**GEORGETOWN-SCOTT COUNTY PLANNING COMMISSION**

**AGENDA**

**SEPTEMBER 9, 2021**

## Staff Report to the Georgetown-Scott County Planning Commission SEPTEMBER 9, 2021

**PURPOSE OF PLAN:**  
 TO REFLECT A CONCEPTUAL DEVELOPMENT OF THIS PROPERTY IN CONJUNCTION WITH THE ZONE CHANGE REQUEST TO R-2 (PUD).

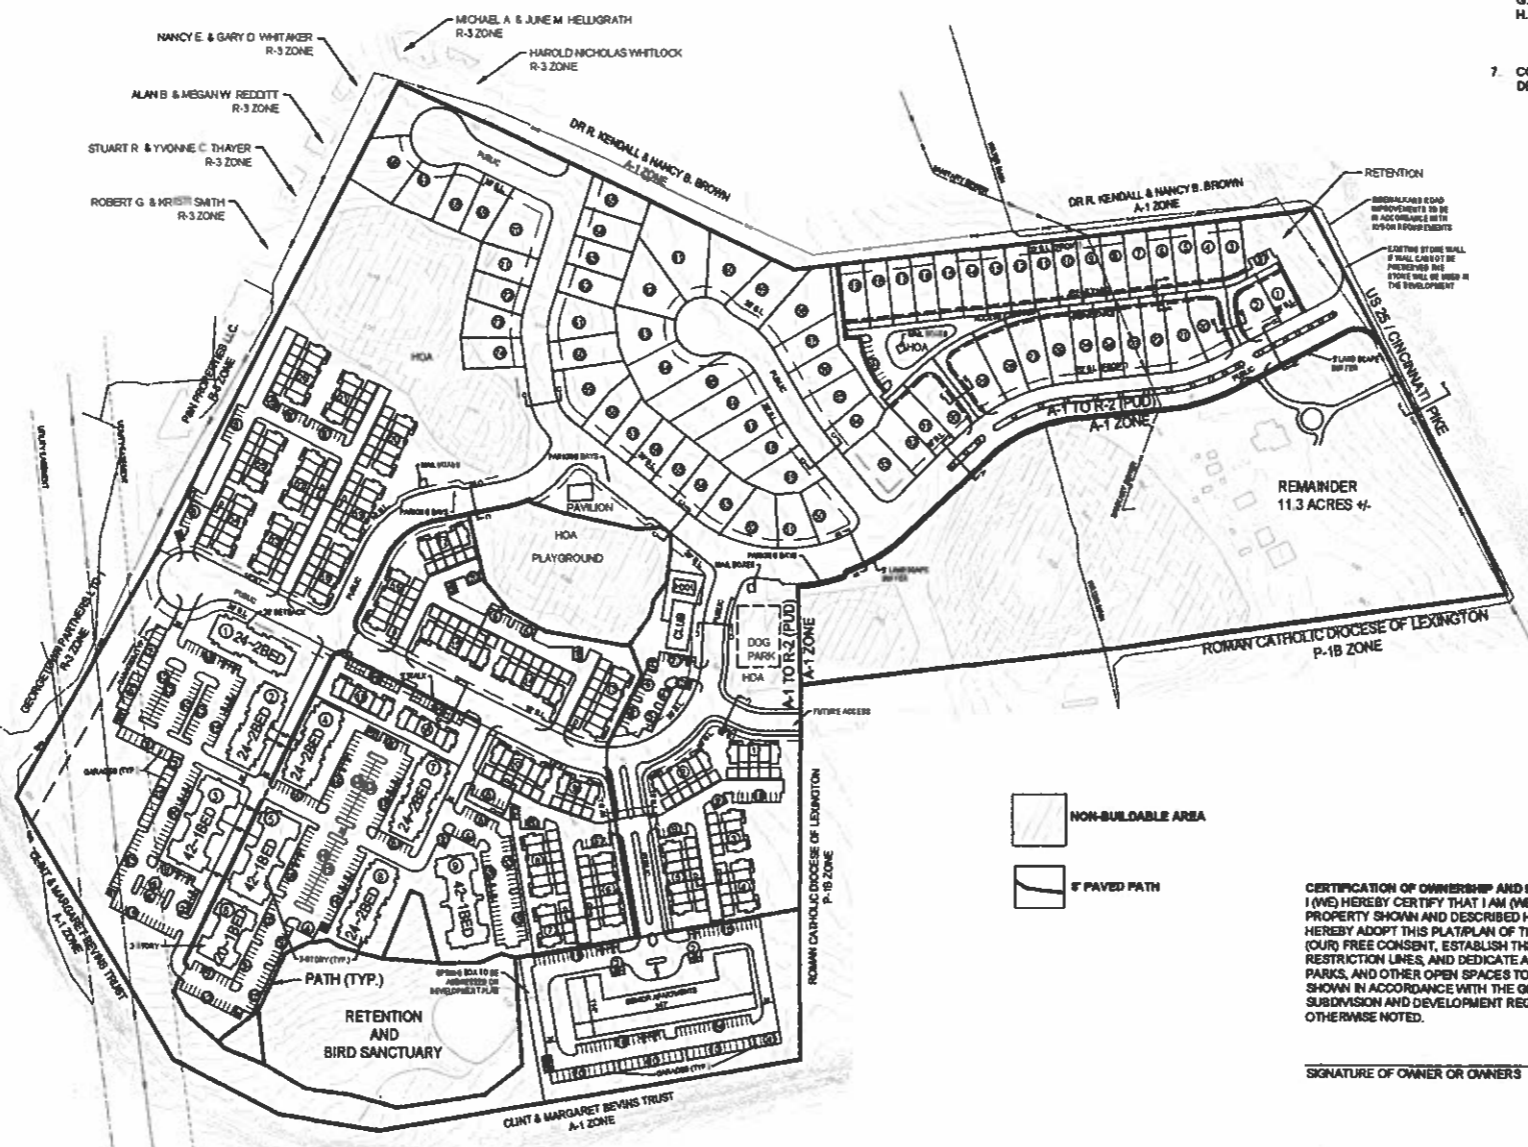
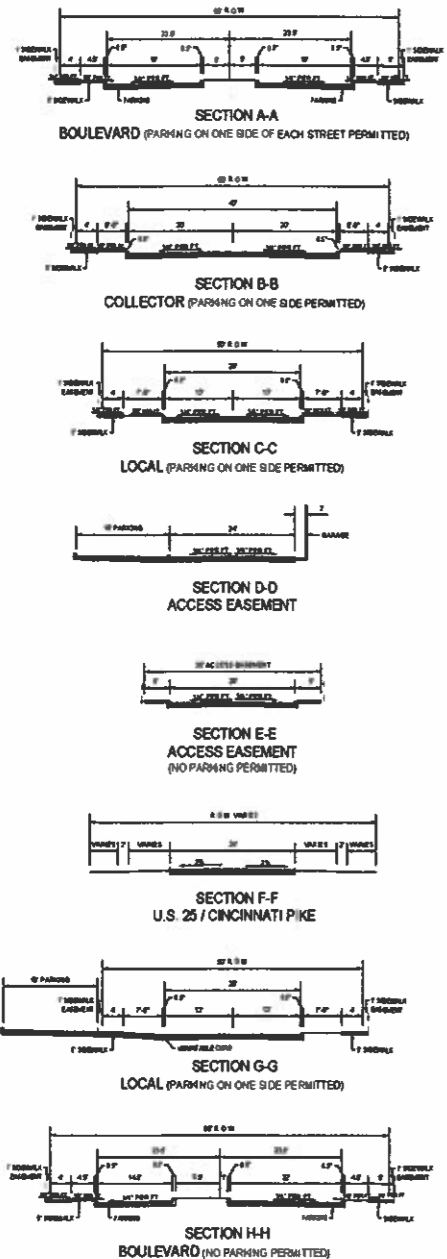
One major issue with the Concept Plan is that it lays out a 581 residential unit development with only a single connection proposed to an existing public street. The *Subdivision & Development Regulations* require single-family developments of 200 or more units and multi-family developments of 100 or more units to have at least two entrance intersections [Article X (P)(7)]. In mixed density developments the Planning Commission has previously required a second entrance intersection at 150 units or more, and staff recommends this same standard be applied to this development as well if it is approved. The Concept Plan does not comply with the *Subdivision & Development Regulations* requirements for the number of entrance intersections. The Project Site does not have enough road frontage, or access to other public streets to be able to meet the intersection requirement currently.

It was brought to the Planning Commission's attention that the neighboring property owner to the south has an access easement across the Project Site that is not accounted for on the Concept Plan. The Applicant has included an area along the western boundary that could potentially be used for access to the south. Staff is uncertain of how usable an access at this location could be given the elevation changes in the area due to the old railroad bed and North Elkhorn Creek. If such an access were feasible it appears it would also likely require construction work in the floodplain. Although the proposed location is not ideal, it does demonstrate that a connection to the A-1 zoned property to the south is conceptually possible.

Staff's largest concern with the concept plan and development of the site at an R-2 density is vehicular access. The plan shows a connection to US 25, a road stub to the Brown Property to the north, and a "future access" to the Cardome Property. Consideration should be given to additional connections to The Colony to the west and the Bevins Property to the south. Our neighborhoods and developments are enriched by additional transportation connections to the community. The Applicant's project at Amerson Orchard is a good example. That development has several connections to arterial roads as well as a connection to the adjoining neighborhood. These connections spread out the traffic flow and keep each individual entrance to a development from getting backed up to the point that it causes frustration for drivers. As the plan is currently drawn, staff has major concerns about how many vehicles would need to be utilizing a single entrance until an unknown date in the future when the stub to the Brown Property or a future access through Cardome connects to public roads that reach US 25 or other major roads. Staff recommends limiting the number of residences that can be built on the Project Site until a second connection to a public road is made.

The highest density portion of the development is shown to be on the southern part of the Project Site. While this provides distance from US 25, Cardome, and the historic house on the remainder, it creates a situation where the largest buildings proposed are all grouped along the southern boundary, potentially creating a visual burden to a single adjoining neighbor. While there is an existing tree line and old railroad bed to the south, it is not owned or controlled by the Applicant, so there are no guarantees that the screening will be a long-term feature. Most of the apartment buildings shown on the Concept Plan are proposed to be 3-stories or 38 feet tall. The Applicant has proposed reducing the height of the southernmost apartment building to 2 stories.

1. Exceed maximum building height up to 38 ft. and 3 stories for apartments and senior apartments. *Staff does not recommend approval of this variance until the Preliminary Development Plan is submitted. Staff would prefer that the Planning Commission wait to review this waiver to see if the size and scale of some of the apartments could be reduced along some of the less intensively used*

3. Exceed the maximum units per building to 7 for townhomes, 42 for apartments, and 90 for senior apartments. *Staff supports granting a waiver to allow for 7 unit townhome buildings and a 90 unit senior apartment. At TRC, staff indicated that there were not any concerns with a 42-unit apartment building, but after further review of the concept plan staff believes it may be better to wait to decide on the number units allowed in these until the Preliminary Development Plan. As was described earlier, if there is a way to reduce the size and scale of some of the proposed buildings a 42-unit building may not be necessary.*

8. Reduce the minimum parking required to the greater of 0.9 spaces per bedroom or 1.5 spaces per unit for the apartments. *It would be more appropriate to analyze parking requirements at the time that a Preliminary Development Plan is submitted.*

1. All applicable requirements of the *Zoning Ordinance and Subdivision & Development Regulations*.
2. The Applicant shall annex the Project Site into the City of Georgetown.
3. The Applicant is responsible for providing a legal description of the Project Site to the City of Georgetown as part of the Zoning Map Amendment process.
4. The Planning Commission shall not approve more than 150 dwelling units to be constructed until the development has at least two connections to off-site public roads.
5. The Applicant shall construct turn lanes, as described in the Traffic Impact Study, as part of the first Development Plan/Subdivision Plat for the Project Site.

**JACOBS PROPERTY  
FINAL SUBDIVISION PLAT**

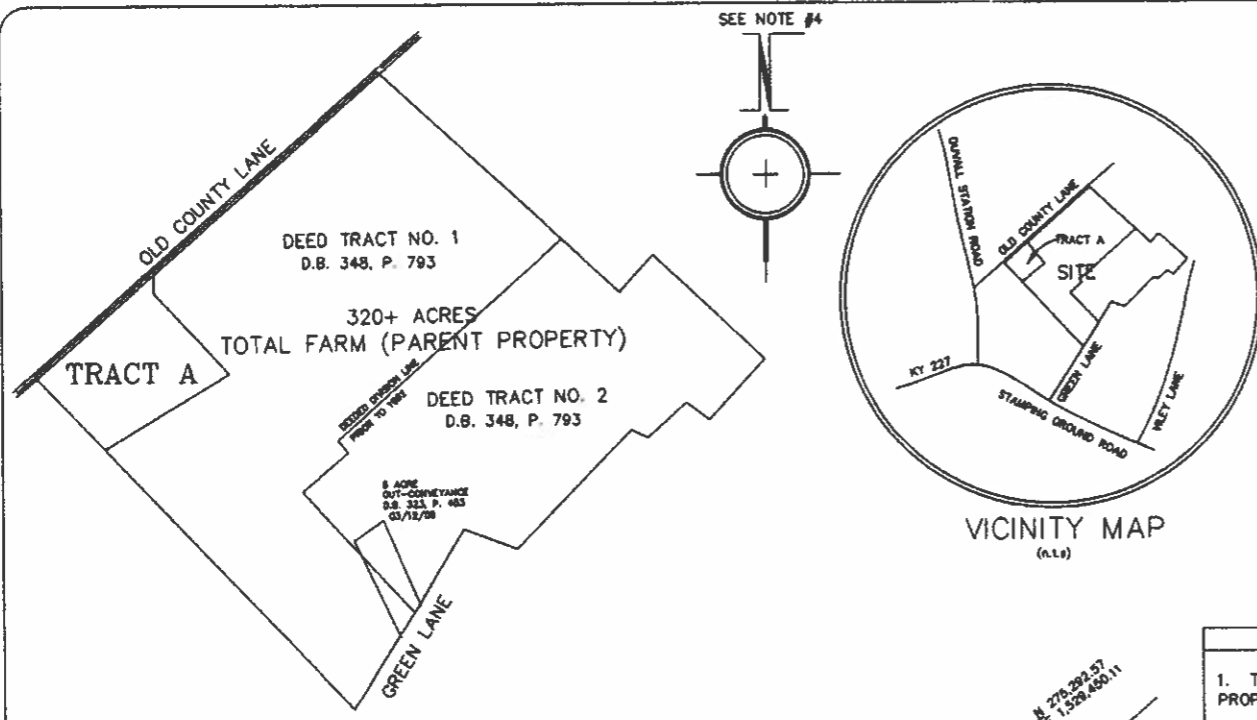
Access to Tract A is proposed from Old County Lane, a private road that does not meet county road standards. Since Old County Lane does not meet these standards, it cannot provide access to more than 3 lots per Article X, (Q) (1) (a) (iv) of the *Subdivision and Development Regulations*. The private road already provides access to more than three lots. From staff's estimation from aerial imagery, it looks like the private road is used by seven lots including the Project Site. The Applicant has agreed, as part of this application, to abandon the right to use Old County Lane for the remainder of the farm. This would

allow the proposed 18-acre lot to use the private road without a net addition of lots to the road. The remainder of the farm would still have adequate road access from Green Lane, which is a public road.

The Applicant has included a note on the plat (#13) clarifying that not additional subdivision of the proposed 18-acre lot or the remainder farm (that would use Old County Lane) will be approved by the Planning Commission unless the roadway meets the requirements of the *Subdivision and Development Regulations*.

5. A note shall be added to the plat (note 14) stating that the remainder of the farm abandons the right to use Old County Lane unless it becomes a public road in the future.

PRELIMINARY DEVELOPMENT PLAN

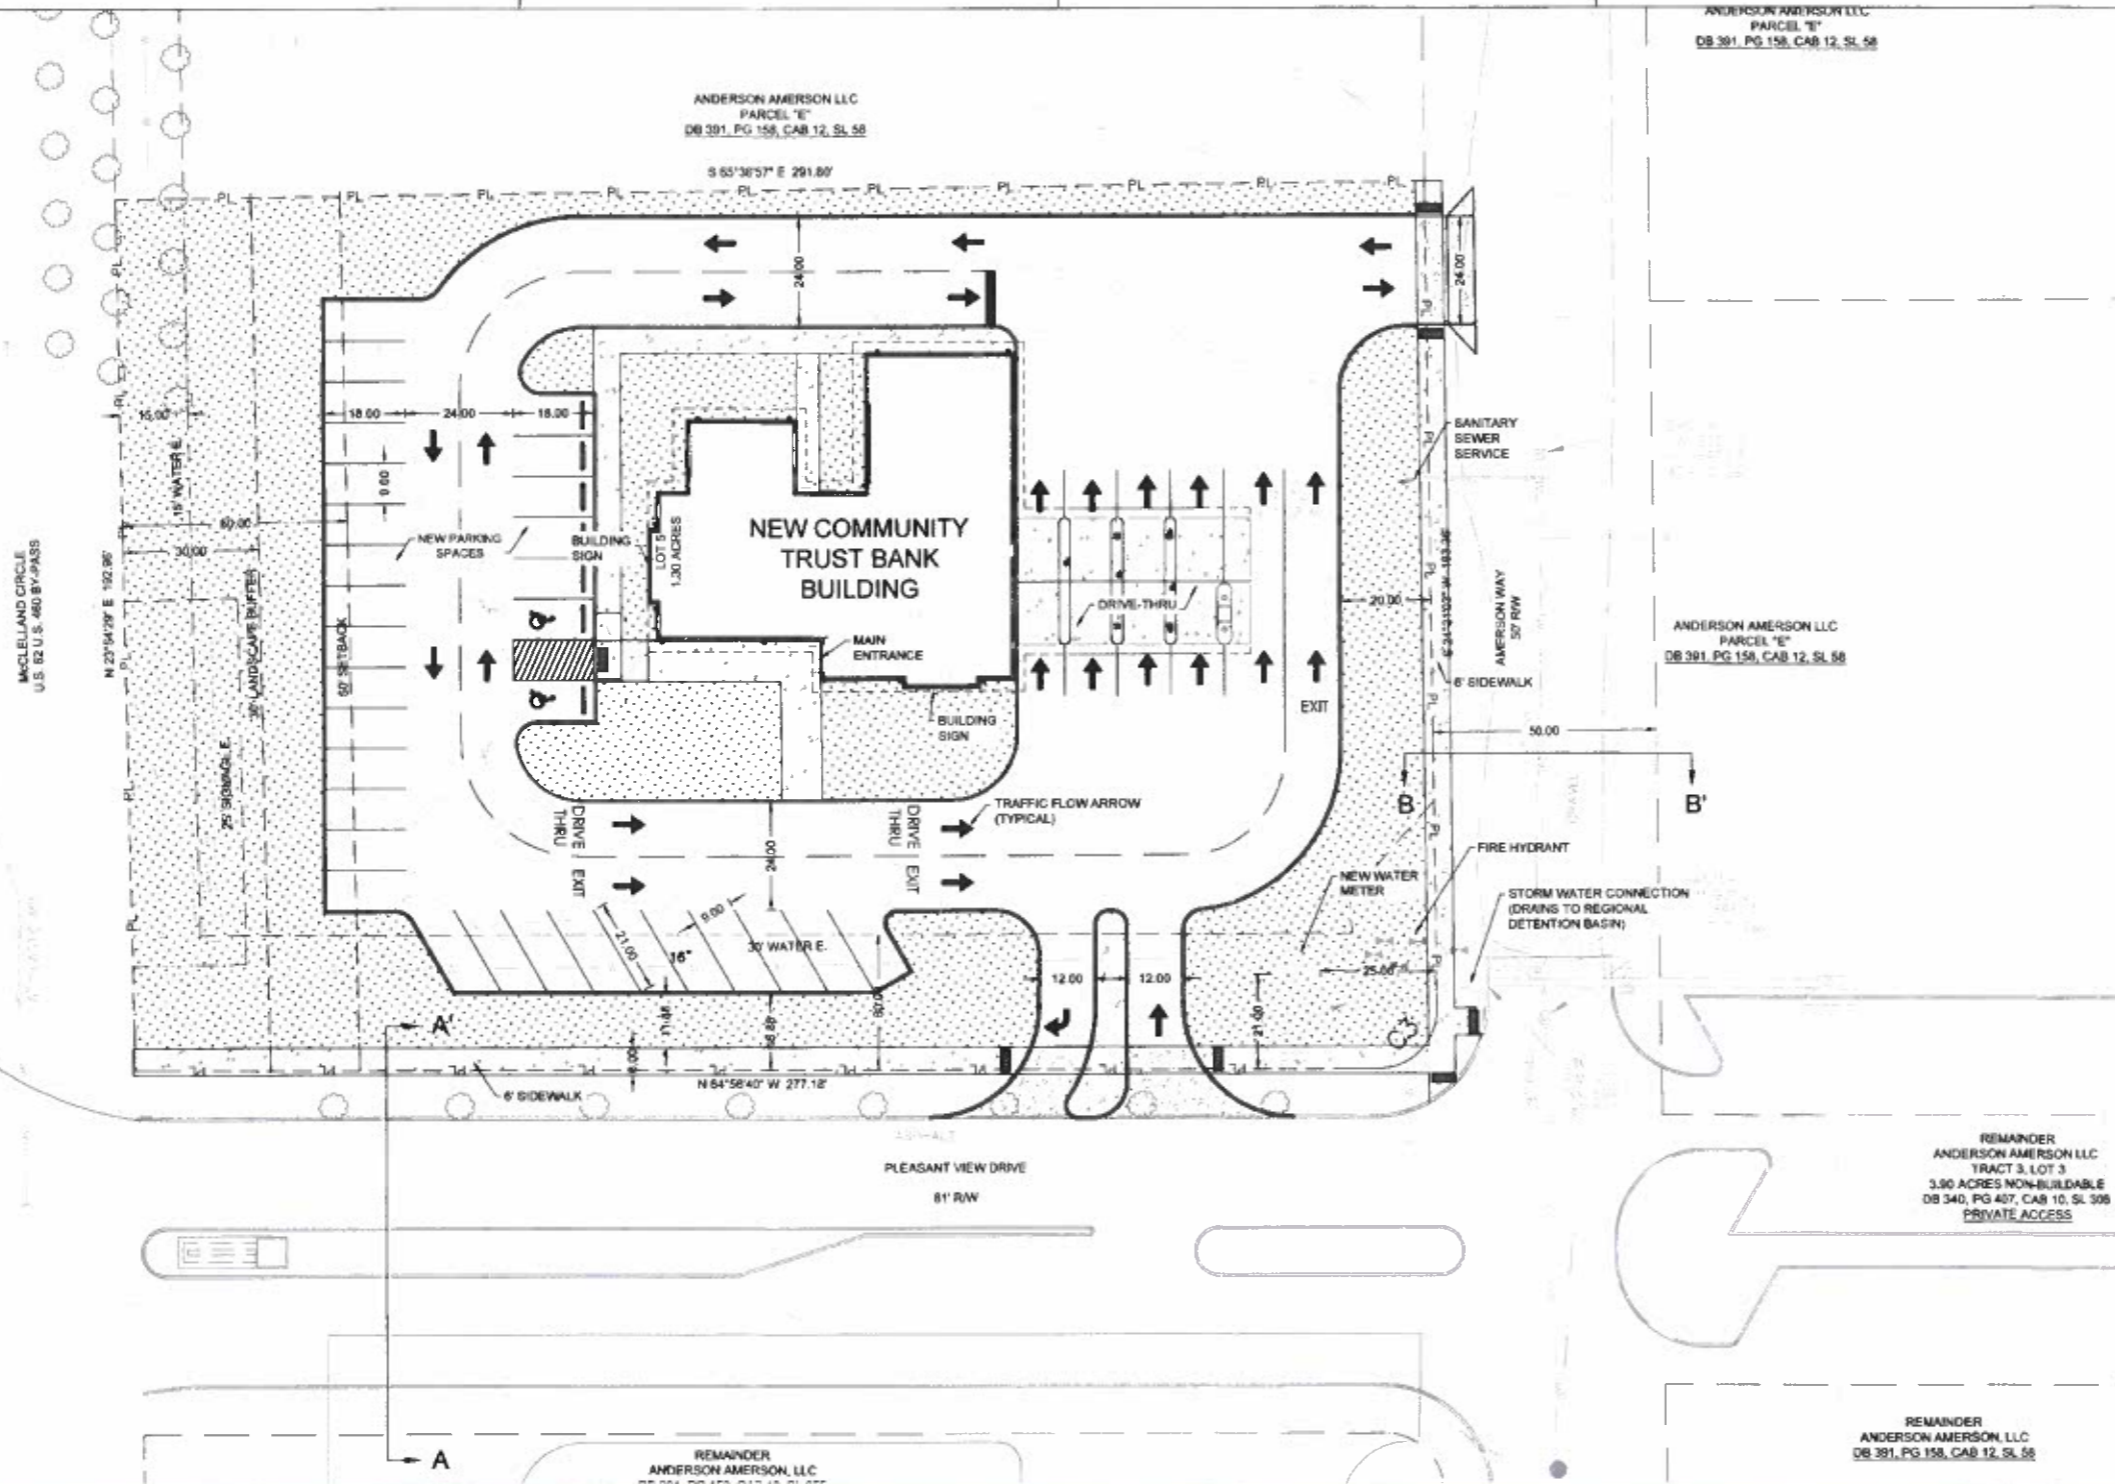
With the exception of the building placement on the lot, the project is meeting all the performance requirements of the B-4 District. Staff is in support of the project. There are two changes staff would like made to the plan. The first, is for a cross access easement and driveway stub be shown between this lot and the adjoining commercial parcel to the north and secondly, a sidewalk connection or striped pedestrian walkway be shown from the public right-of-way to the building entrance.

3. A sidewalk/walkway connection shall be provided from the sidewalk on public right-of-way to the building entrance.
4. Any revisions or amendments to the approved Preliminary Development Plan shall be reviewed and approved by the Planning Commission staff (minor) or by the Planning Commission (major).

**PRELIMINARY LANDSCAPE PLAN**

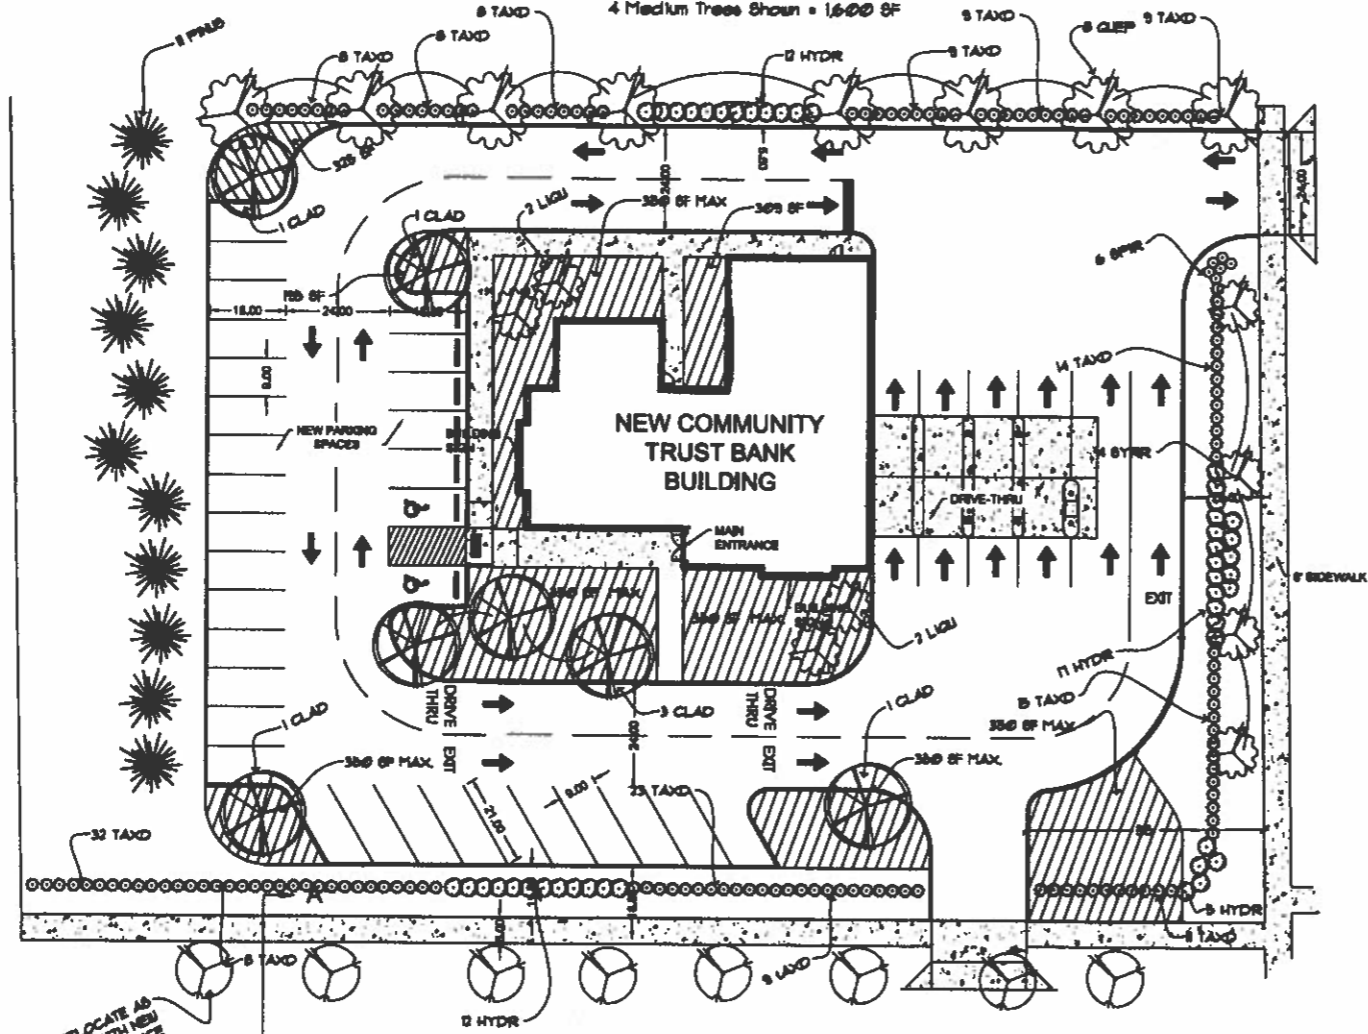
The Preliminary Development Plan needs to add a hedge and tree every 40' along the McClelland Circle frontage for VUA perimeter landscaping. Currently its showing a line of evergreen trees, which is atypical for VUA screening. Trees are being shown along the interior frontages where street trees already exist or are required. The street trees can count towards the VUA perimeter tree requirement, so some trees may be removed at the applicants discretion on the Final Development Plan.

9. The Final Development Plan shall have a specie specific Landscaping Plan in compliance with the *Landscaping & Land Use Buffers Ordinance*.
